**Community Development Department**

**NOTICE OF DECISION**  
 Atlas – Site Plan Review

<b>Land Use Application Nos.:</b>	SPR 20-010 (Site Plan Review) BLA 20-006 (Boundary Line Adjustment) SEP 20-015 (SEPA) CAP 20-004 (Critical Areas Permit)
<b>Applicant:</b>	Samuel Duguay Jackola Engineering and Architecture 702 Jefferson ST Vancouver, WA 98660
<b>Property Owner:</b>	Sarah and Kaarle Homola 428 N Pekin RD Woodland, WA 98674
<b>Site Location:</b>	428 N Pekin Woodland, WA 98674
<b>Parcel &amp; Size:</b>	50739, 50741, 50740, 3.69 Acres
<b>Zoning Designation:</b>	Heavy Industrial (I-2)
<b>Date Application Received:</b>	December 14, 2020
<b>Notice of Application &amp; Likely DNS issued:</b>	January 22, 2021
<b>Comment Period &amp; SEPA Appeal Period Ended:</b>	February 17, 2021
<b>Notice of Decision Issued:</b>	March 11, 2021
<b>DRC Decision:</b>	Approve with Conditions

**Attachment A**  
Site Plan

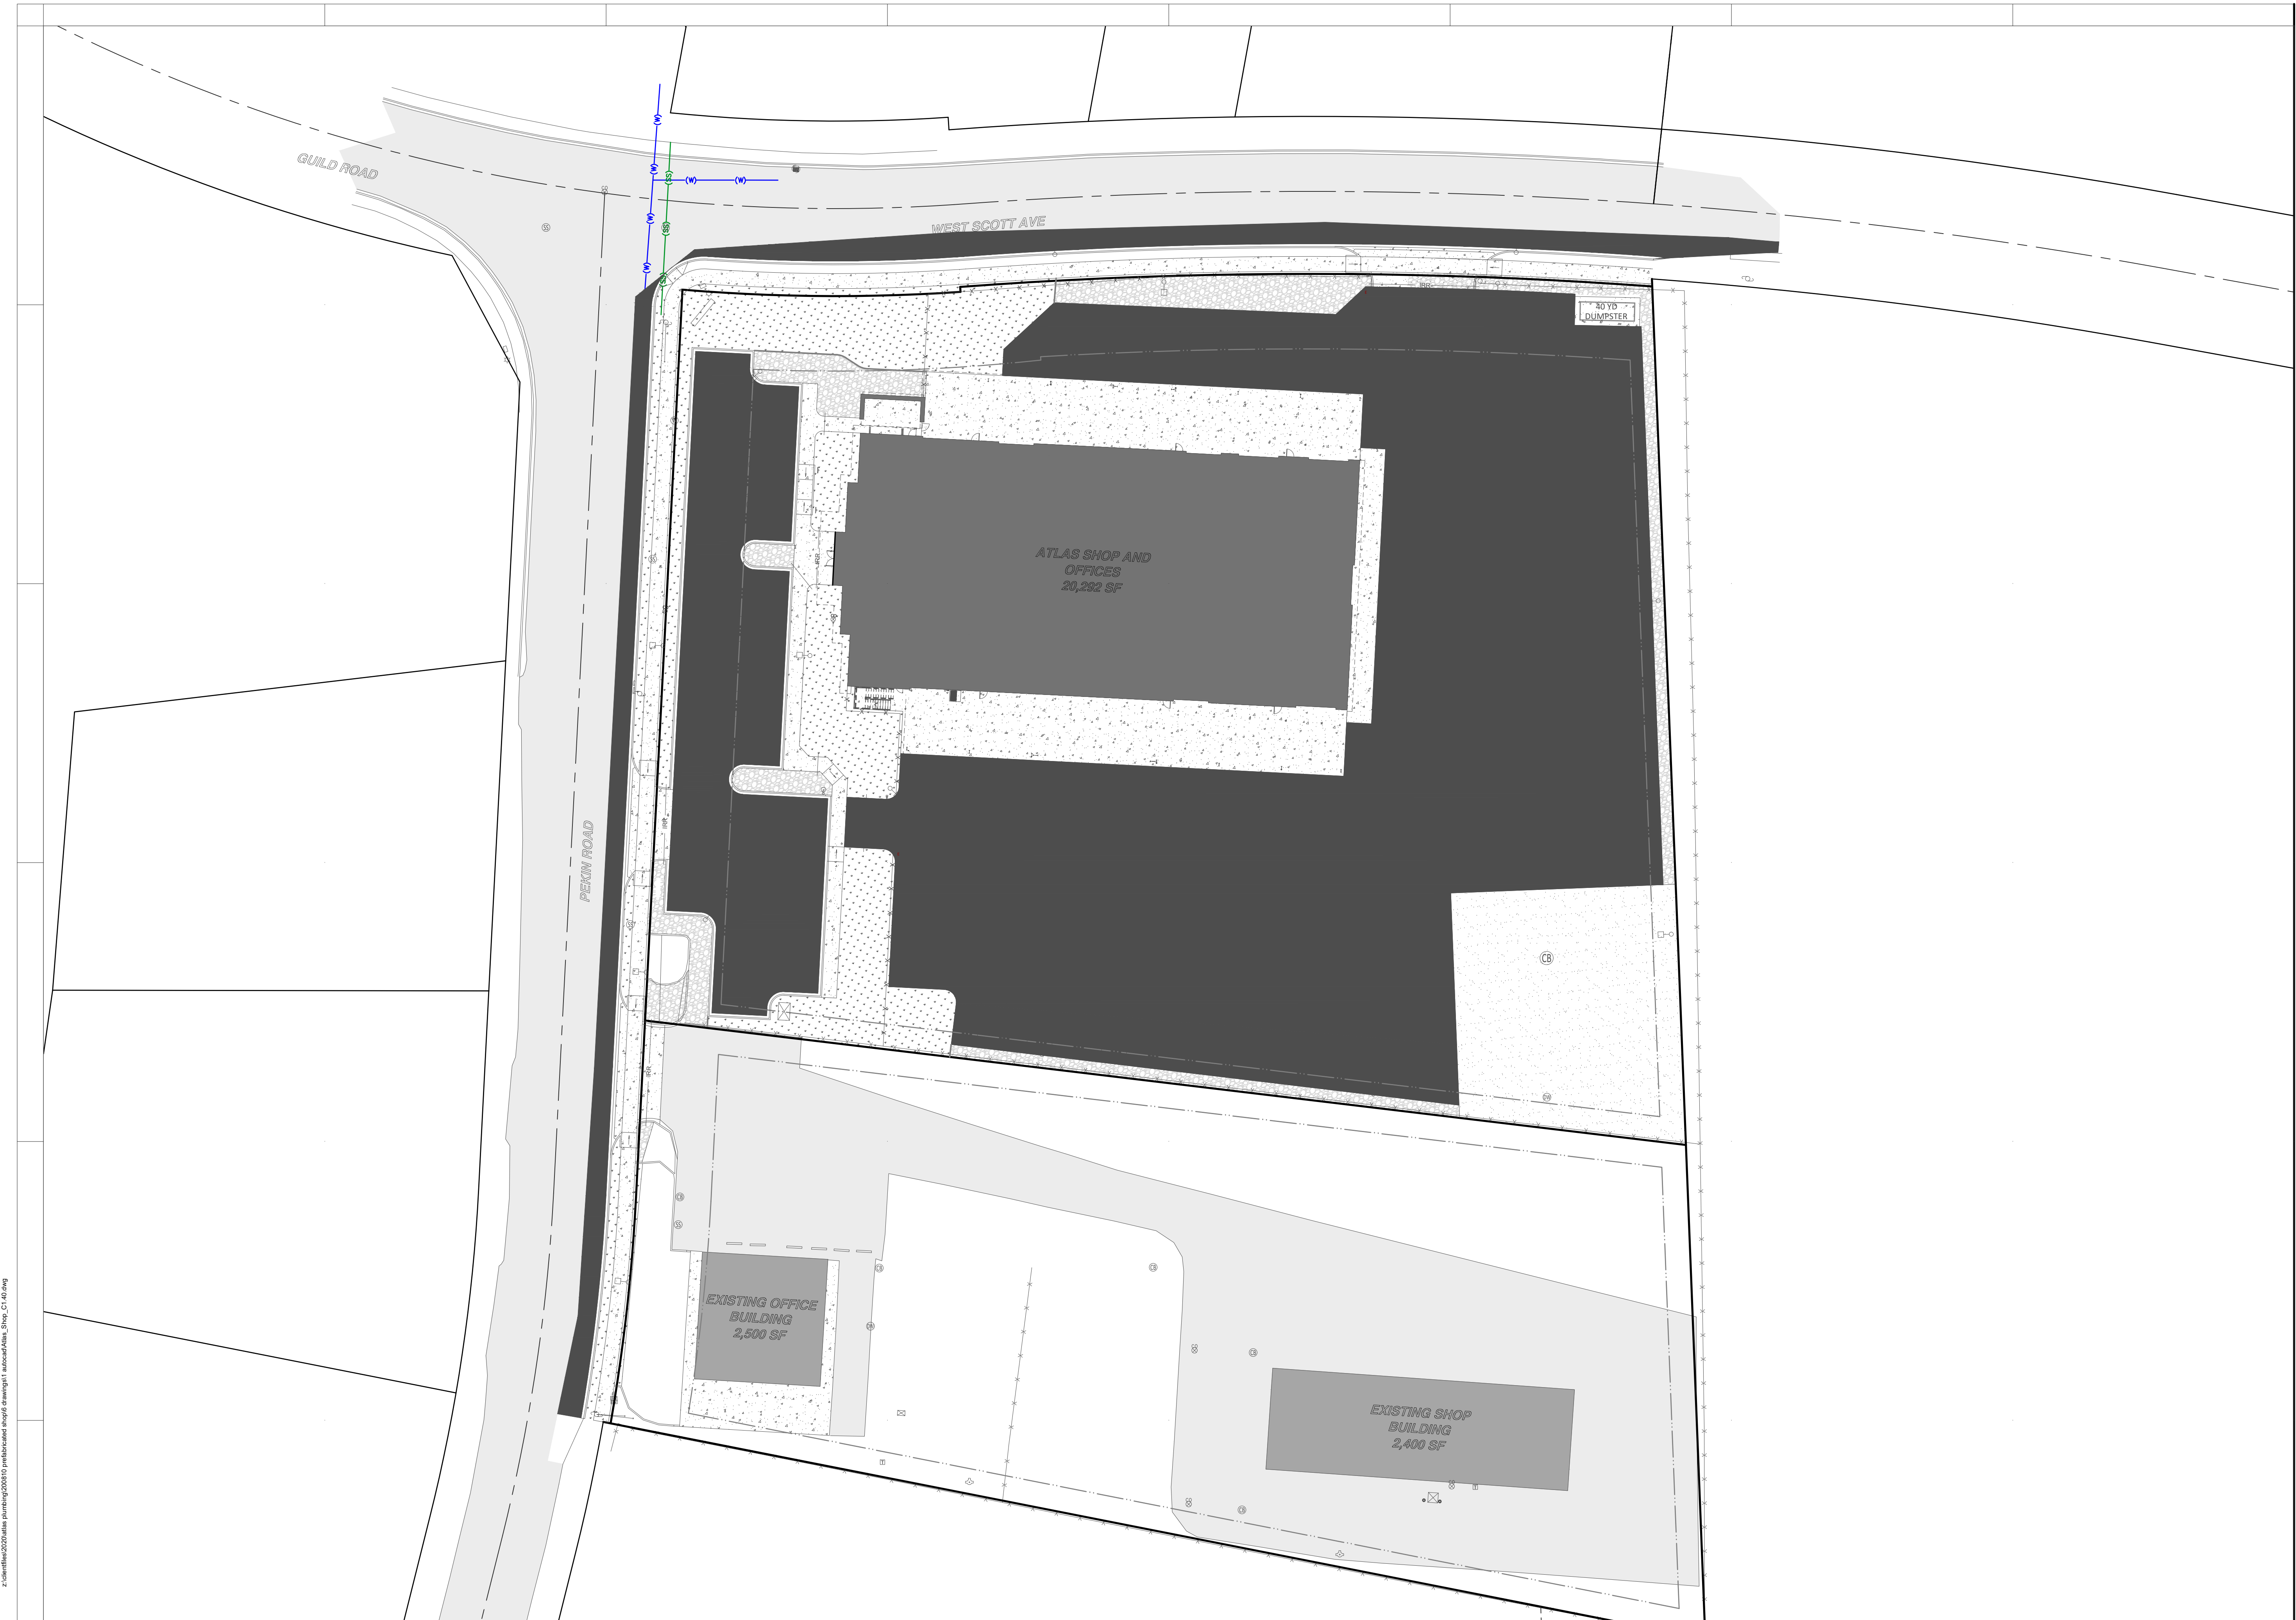
**Finding 22:** The proposed building is located over 60 ft. from N. Pekin Road and West Scott Avenue. It is located 120 ft. from the southern and eastern property lines. The proposal meets the required setbacks. *See Attachment A – Site Plan.*

**Finding 31:** The total landscaped area calculation was not included on the landscaping plan and a condition is added to include this calculation. The narrative indicates 10% of the site will be covered in landscaping which would meet code. *See Condition #14. See Attachment A: Site Plan.*

**Finding 47:** Public Works requires street tree plantings in the right-of-way in the planting strip between the sidewalk and road. A condition is added to revise the proposed right-of-way planting using the Woodland Street Tree list and adhering to WMC 12.28. *See Attachment A: Site Plan and Condition #20.*

**Finding 72:** Thirty-five parking spaces and including two accessible parking spaces are proposed for 20 employees and visitors. *See Attachment A: Site Plan.*

**SITE  
 LANDSCAPING  
 PLAN**

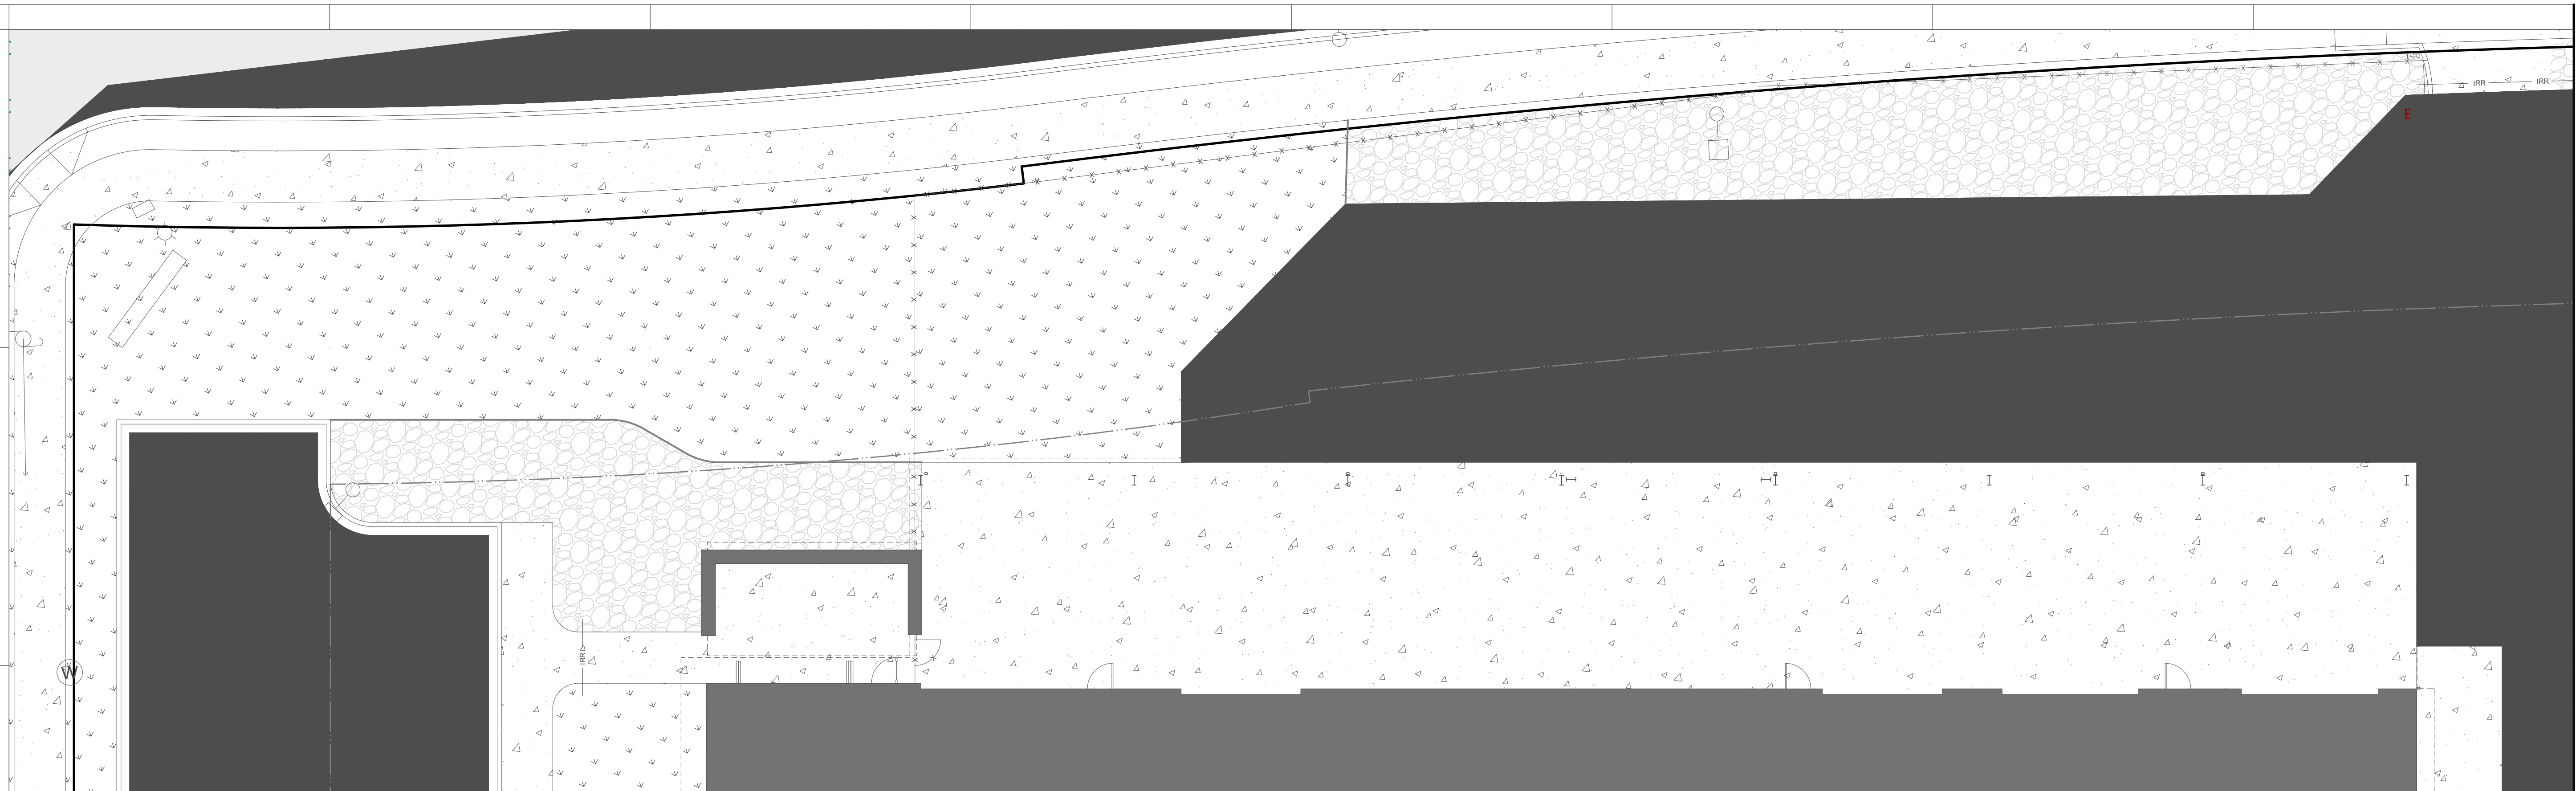
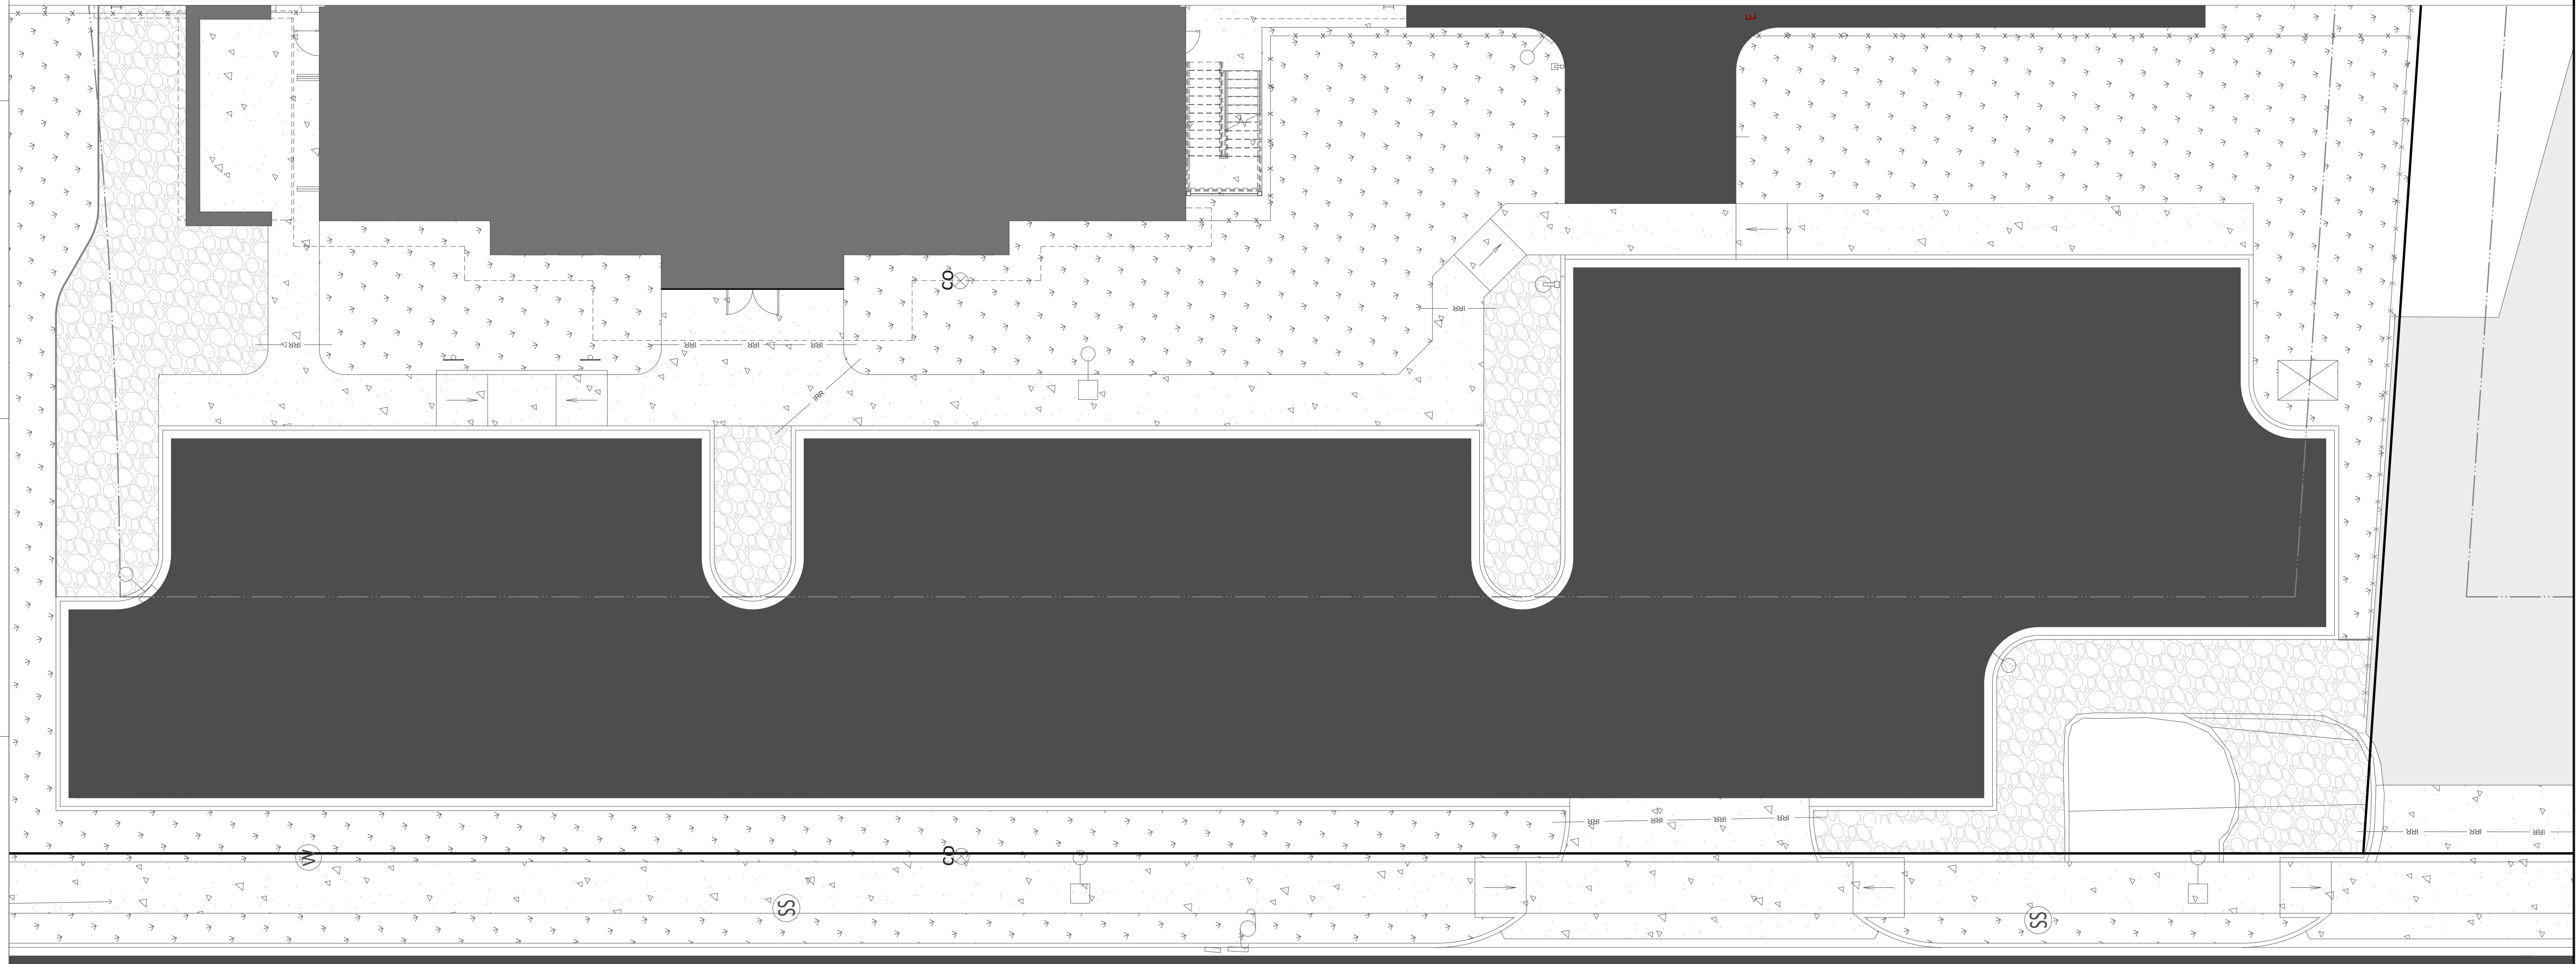
**Finding 29:** The proposed landscaping plan did not include tabulations showing area and percentage for:

- Entire site;
- Total landscaping areas;
- Areas covered by groundcover;
- Areas covered by nonplant materials (as described in WMC 17.44.135 (G));
- Areas covered by tree canopy and shrubs;
- Each required setback area (as specified in WMC 17.44.070);
- Total parking area;
- Parking landscaping; and
- Other landscaping areas.

**Finding 37:** The size of the proposed trees is not indicated on the landscaping plan. The minimum size of 2-inch caliper should be indicated on the landscaping plan. *See Condition #16.*

**Finding 39:** The type, size, and location of proposed shrubs is not included on the landscaping plan. A condition is added to include these details on the landscaping plan. *See Condition #17.*

**Finding 45:** The landscaping plan should include a plant guarantee and irrigation plan for all plants that are not drought tolerant. A condition is added for the owner (or contractor) to replace plantings that fail to survive. And a condition is added to detail irrigation plans on the landscaping plan. *See Condition #19.*

**Finding 51:** The plantings proposed in the front setback only include hydroseed. A condition is added to revise the landscaping plan showing trees, shrubs, and groundcover in the front yard landscaping area. See *Condition #21*.

**Finding 57:** The parking lot consists of 35 parking spaces. At least seven trees will be required. The location and tree species must be indicated on the landscaping plan. See *Condition #23*.

**Finding 59:** The parking area is within the required front yard setback. Screening will be required per WMC 17.46.126 (F)(3). A condition is added to include parking lot screening on the landscaping plan. *See Condition #24.*

13. The proposed landscaping plan does not include tabulation showing the area and percentage for:
  - a. Entire site;
  - b. Total landscaping areas;
  - c. Areas covered by groundcover;

- d. Areas covered by nonplant materials (as described in WMC 17.44.135 (G));
  - e. Areas covered by tree canopy and shrubs;
  - f. Each required setback area (as specified in WMC 17.44.070);

14. Demonstrate on the final landscaping plan how the 10% landscaping standard, WMC 17.46.125, will be met.
15. Include a proposed planting list including species of proposed tree, shrub, and groundcover with the landscaping plan.
16. The minimum tree size of 2-inch caliper should be indicated on the landscaping plan.
17. Indicate the size of proposed shrubs on the landscaping plan (minimum size is 5-gallon containers).

19. Add a note to the landscaping plan that the owner is required to replace plantings that fail to survive after the contractor guarantee expires. Add irrigation plans to the landscaping plan.

21. Revise the landscaping plan with additional trees and shrubs along the frontage in the front yard per WMC 14.46.126 (B).
22. Include a five-foot wide planting strip along the property line across from parcels 507770100 and 507940100. The planting strip must include view-obscuring evergreen trees and shrubs not less than 6 ft. in height per WMC 17.46.126 (E).

23. For the proposed 35 parking spaces, at least seven trees will be required per WMC 17.46.126 (F). The location and tree species must be indicated on the landscaping plan.

24. Parking lot screening will be required per WMC 17.46.126 (F)(3). Add an evergreen hedge or decorative wall or other treatment per WMC 17.46.126(F)(3) to the landscaping plan.

**2 WEST ELEVATION**  
1/8" = 1'-0"

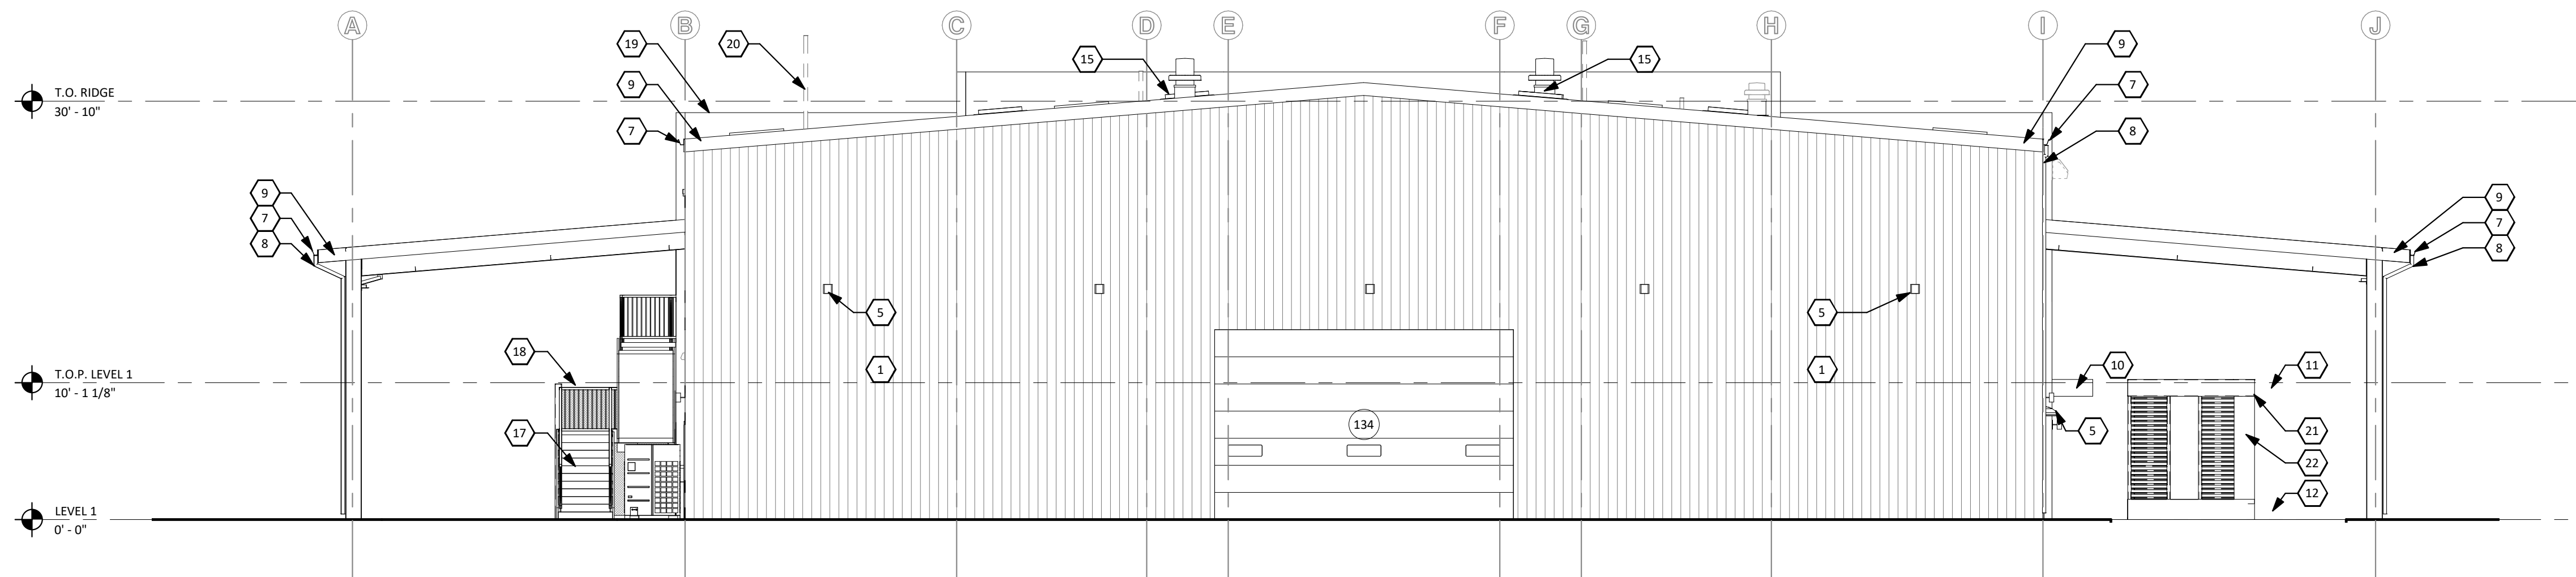
**Finding 66:** The north and west building elevations face the street and must meet the façade standards in WMC 17.46.160 (C). The north and west building elevations do not meet the standard. A condition is added to revise the building elevations to comply with WMC 17.46.160 (C). *See Condition #29. See Attachment B – Building Elevations.*

29. The north and west building elevations face the street and must meet the façade standards in WMC 17.46.160 (C). Revise the building elevations to comply with WMC 17.46.160 (C). Resubmit building elevations with the final civil engineering and revise prior to submitting building permits.
